Heavy Vehicle Local Road (HVLR) Assessment

North Strathfield Heavy Vehicle Local Road
Approval for Sydney Metro West

CLNK-SYNC-HVLR-NTS

Revision 01
Date: 03 November 2025

Figure 1 Extract from EIS reflecting existing approved access

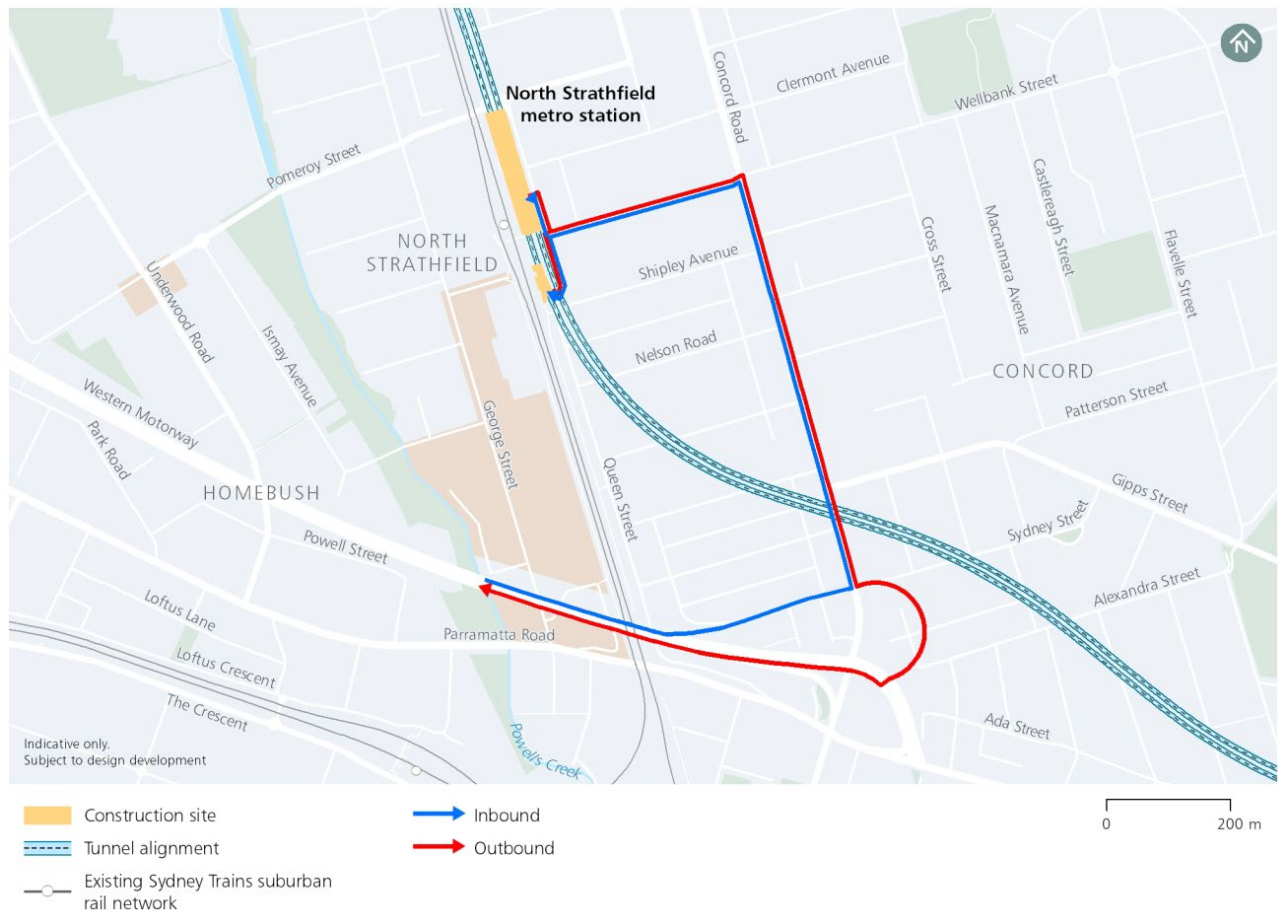
CONTRACT NO.	DOCUMENT NO.	TITLE	VER	STATUS	NO.	DATE	COMPANY	RAISED BY	REVIEW DOC. NO.*	DOCUMENT REF*	DEED REF*	COMMENTS / RESPONSE	COMMENT CATEGORY*
EWNS	SMWSDDS-S	EWNS - Heavy Veh	01.01	RVW	06	15/10/2025	HBI	GKOLLIAS	CLNK-SYNC-HVLR-NTS	Multiple	-	Remove references to CoA E104, E105 and E107 throughout and replace with equivalent CoA condition as required	Observation
EWNS	SMWSDDS-S	EWNS - Heavy Veh	01.01	RVW					CLNK-SYNC-HVLR-NTS	Multiple	-		Observation
EWNS	SMWSDDS-S	EWNS - Heavy Veh	01.01	RVW	06.01	29/10/2025	SYS	AWASHINGTON	CLNK-SYNC-HVLR-NTS	Multiple	-	This has been updated.	Observation
EWNS	SMWSDDS-S	EWNS - Heavy Veh	01.01	RVW					CLNK-SYNC-HVLR-NTS	Multiple	-		Observation
EWNS	SMWSDDS-S	EWNS - Heavy Veh	01.01	RVW	07	15/10/2025	HBI	GKOLLIAS	CLNK-SYNC-HVLR-NTS	Sect 3.1 & Figure 1	D86	EIS Technical Paper 1 – Traffic and Transport Sect 4.12 and Figure 4-29 have the assessed route as "Roads forming part of the construction vehicle route include the M4 Western Motorway, Concord Road, Wellbank Street and Queen Street as shown in Figure 4-29". These same roads are used for Outbound. Route and Figure used if for upcoming Stage of Sydney Metro West, and not the approved Project. Check all assessments and information used throughout HVLR are against the relevant EIS. Pomeroy and Underwood Outbound have not been assessed as part of the correct EIS, and therefore may need further assessment in this document. Revise Sect 3.1 and Figure 1	Actual Non-Compliance

EWNS	SMWSDDS-S	EWNS - Heavy Veh	01.01	RVW					CLNK-SYNC-HVLR-NTS	Sect 3.1 & Figure 1	D86		Actual Non-Compliance
EWNS	SMWSDDS-S	EWNS - Heavy Veh	01.01	RVW	07.01	29/10/2025	SYS	AWASHINGTON	CLNK-SYNC-HVLR-NTS	Sect 3.1 & Figure 1	D86	Noted, however these are Regional Roads and not 'Local Roads' as described in the document and would therefore not meet the classification or criteria for needing further assessment based on their classification. This is already noted in section 3.2.	Actual Non-Compliance
EWNS	SMWSDDS-S	EWNS - Heavy Veh	01.01	RVW					CLNK-SYNC-HVLR-NTS	Sect 3.1 & Figure 1	D86		Actual Non-Compliance
EWNS	SMWSDDS-S	EWNS - Heavy Veh	01.01	RVW	08	15/10/2025	SMD	RBANZON	SMWSDDS-SYS-NST-TF-REP-000010	Section 1	D86, D87, D88 and D89	Please update the referenced conditions to the relevant EIS Stage 1 MCoA	Actual Non-Compliance
EWNS	SMWSDDS-S	EWNS - Heavy Veh	01.01	RVW					SMWSDDS-SYS-NST-TF-REP-000010	Section 1	D86, D87, D88 and D89		Actual Non-Compliance

Figure 2 Road network classifications (<https://maps.transport.nsw.gov.au/egeomaps/road-network-classification/index.html>)

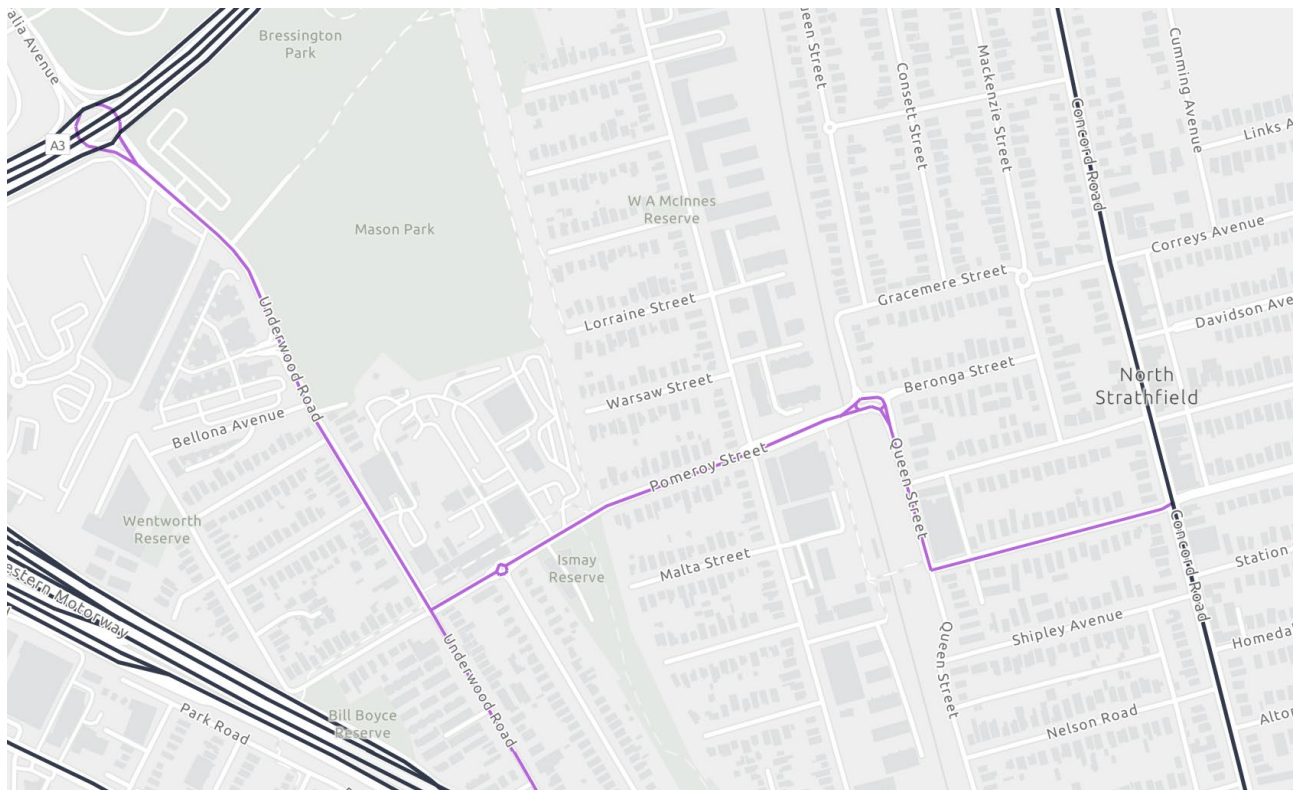
EWNS	SMWSDDS-S	EWNS - Heavy Veh	01.01	RVW					SMWSDDS-SYS-NST-TF-REP-000010	Section 1.2 Table 1	MCoA Traffic and Transport		Actual Non-Compliance
EWNS	SMWSDDS-S	EWNS - Heavy Veh	01.01	RVW	10	15/10/2025	SMD	RBANZON	SMWSDDS-SYS-NST-TF-REP-000010	Section 3.1 Flgure 1	N/A	EIS extract is from the Stage 3 EIS. Please replace with the Stage 1 EIS and update the commentary as required.	Observation
EWNS	SMWSDDS-S	EWNS - Heavy Veh	01.01	RVW					SMWSDDS-SYS-NST-TF-REP-000010	Section 3.1 Flgure 1	N/A		Observation
EWNS	SMWSDDS-S	EWNS - Heavy Veh	01.01	RVW	10.01	29/10/2025	SYS	AWASHINGTON	SMWSDDS-SYS-NST-TF-REP-000010	Section 3.1 Figure 1	N/A	This has been updated.	Observation
EWNS	SMWSDDS-S	EWNS - Heavy Veh	01.01	RVW					SMWSDDS-SYS-NST-TF-REP-000010	Section 3.1 Figure 1	N/A		Observation
EWNS	SMWSDDS-S	EWNS - Heavy Veh	01.01	RVW	11	15/10/2025	SMD	RBANZON	SMWSDDS-SYS-NST-TF-REP-000010	Section 3.2	N/A	Given that Pomeroy St, Underwood Road and Homebush Bay Drive are not approved in the Stage 1 EIS, the Figure 2 map extents should be cover these roads as well.	Observation

CONTRACT NO.	DOCUMENT NO.	TITLE	VER	STATUS	NO.	DATE	COMPANY	RAISED BY	REVIEW DOC. NO.*	DOCUMENT REF*	DEED REF*	COMMENTS / RESPONSE	COMMENT CATEGORY*
EWNS	SMWSDDS-S	EWNS - Heavy Veh	01.01	RVW					SMWSDDS-SYS-NST-TF-REP-000010	Section 3.2	N/A		Observation
EWNS	SMWSDDS-S	EWNS - Heavy Veh	01.01	RVW	11.01	29/10/2025	SYS	AWASHINGTON	SMWSDDS-SYS-NST-TF-REP-000010	Section 3.2	N/A	This has been updated.	Observation
EWNS	SMWSDDS-S	EWNS - Heavy Veh	01.01	RVW					SMWSDDS-SYS-NST-TF-REP-000010	Section 3.2	N/A		Observation
EWNS	SMWSDDS-S	EWNS - Heavy Veh	01.01	RVW	12	15/10/2025	SMD	RBANZON	SMWSDDS-SYS-NST-TF-REP-000010	Section 3.3	N/A	Commentary should be updated to mention that access and egress also uses a combination of regional roads that are discussed in the CTMP.	Observation
EWNS	SMWSDDS-S	EWNS - Heavy Veh	01.01	RVW					SMWSDDS-SYS-NST-TF-REP-000010	Section 3.3	N/A		Observation
EWNS	SMWSDDS-S	EWNS - Heavy Veh	01.01	RVW	12.01	29/10/2025	SYS	AWASHINGTON	SMWSDDS-SYS-NST-TF-REP-000010	Section 3.3	N/A	This has been added.	Observation

Figure 3 Proposed additional heavy vehicle access and egress

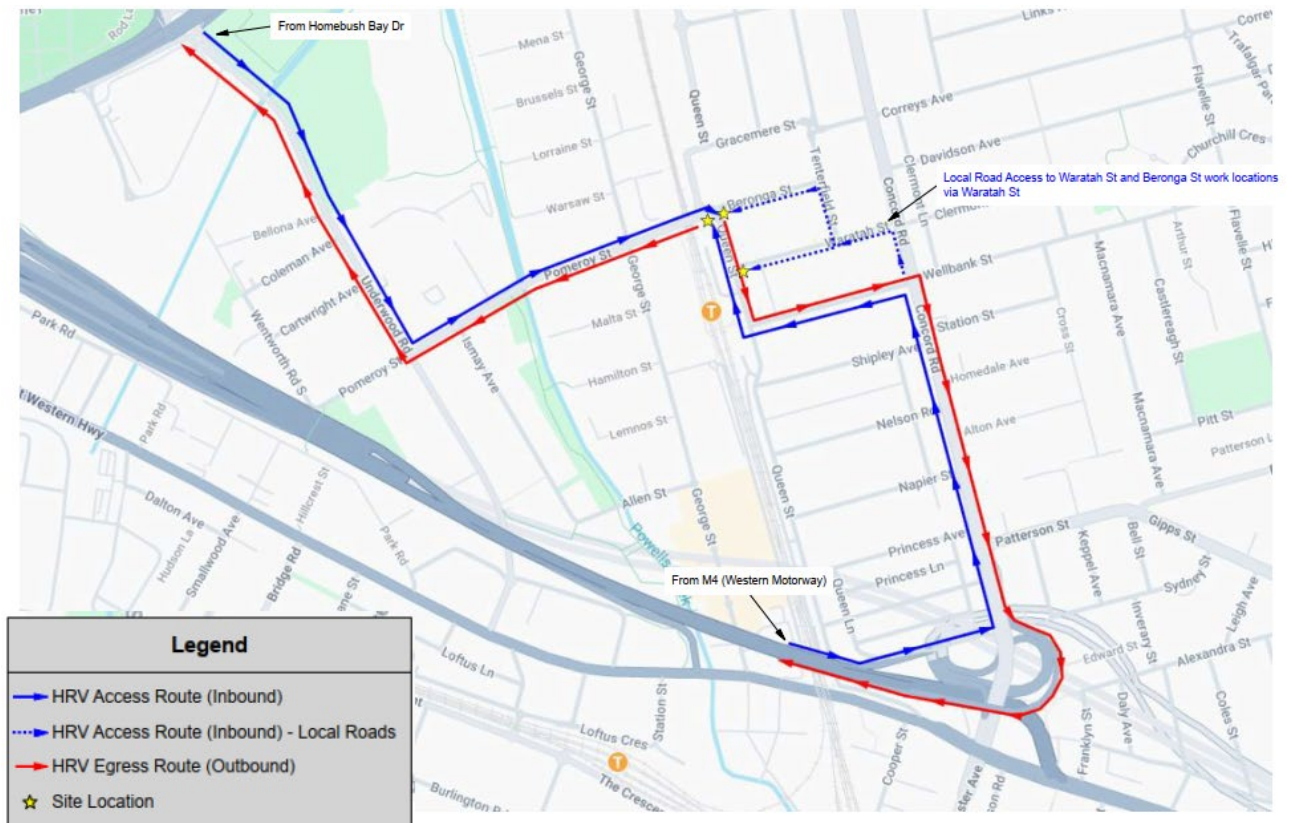
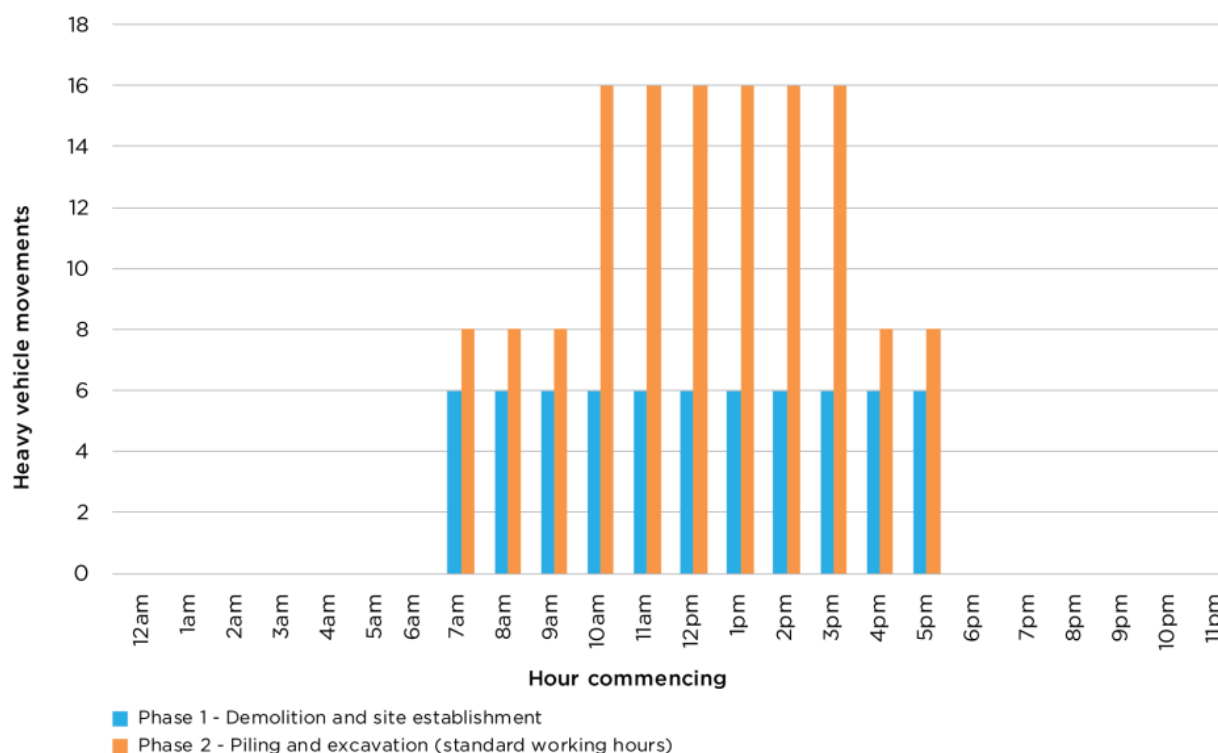
EWNS	SMWSDDS-S	EWNS - Heavy Veh	01.01	RVW					SMWSDDS-SYS-NST-TF-REP-000010	Section 3.3	N/A		Observation
EWNS	SMWSDDS-S	EWNS - Heavy Veh	01.01	RVW	13	15/10/2025	SMD	RBANZON	SMWSDDS-SYS-NST-TF-REP-000010	Section 3.3 Figure 3 and Figure 4	N/A	Please add a key to the figures to show that the blue line is access/ingress and the pink line is egress	Observation
EWNS	SMWSDDS-S	EWNS - Heavy Veh	01.01	RVW					SMWSDDS-SYS-NST-TF-REP-000010	Section 3.3 Figure 3 and Figure 4	N/A		Observation
EWNS	SMWSDDS-S	EWNS - Heavy Veh	01.01	RVW	13.01	29/10/2025	SYS	AWASHINGTON	SMWSDDS-SYS-NST-TF-REP-000010	Section 3.3 Figure 3 and Figure 4	N/A	This has been updated in the VMP figure, and the legend is included for clarity.	Observation
EWNS	SMWSDDS-S	EWNS - Heavy Veh	01.01	RVW					SMWSDDS-SYS-NST-TF-REP-000010	Section 3.3 Figure 3 and Figure 4	N/A		Observation
EWNS	SMWSDDS-S	EWNS - Heavy Veh	01.01	RVW	14	15/10/2025	SMD	RBANZON	SMWSDDS-SYS-NST-TF-REP-000010	Section 3.4 Figure 5	N/A	Please replace the EIS Stage 3 graph with the EIS Stage 1 graph, and update the commentary as required	Observation

EWNS	SMWSDDS-S	EWNS - Heavy Veh	01.01	RVW					SMWSDDS-SYS-NST-TF-REP-000010	Section 3.4 Figure 5	N/A		Observation
EWNS	SMWSDDS-S	EWNS - Heavy Veh	01.01	RVW	14.01	29/10/2025	SYS	AWASHINGTON	SMWSDDS-SYS-NST-TF-REP-000010	Section 3.4 Figure 5	N/A	This has been updated.	Observation
EWNS	SMWSDDS-S	EWNS - Heavy Veh	01.01	RVW					SMWSDDS-SYS-NST-TF-REP-000010	Section 3.4 Figure 5	N/A		Observation
EWNS	SMWSDDS-S	EWNS - Heavy Veh	01.01	RVW	15	15/10/2025	SMD	RBANZON	SMWSDDS-SYS-NST-TF-REP-000010	Section 3.5	N/A	Please update the referenced document to the relevant EIS Stage 1 document	Observation
EWNS	SMWSDDS-S	EWNS - Heavy Veh	01.01	RVW					SMWSDDS-SYS-NST-TF-REP-000010	Section 3.5	N/A		Observation
EWNS	SMWSDDS-S	EWNS - Heavy Veh	01.01	RVW	15.01	29/10/2025	SYS	AWASHINGTON	SMWSDDS-SYS-NST-TF-REP-000010	Section 3.5	N/A	This has been updated, in this instance removed as the Stage 1 document does not appear to provide the same detail.	Observation
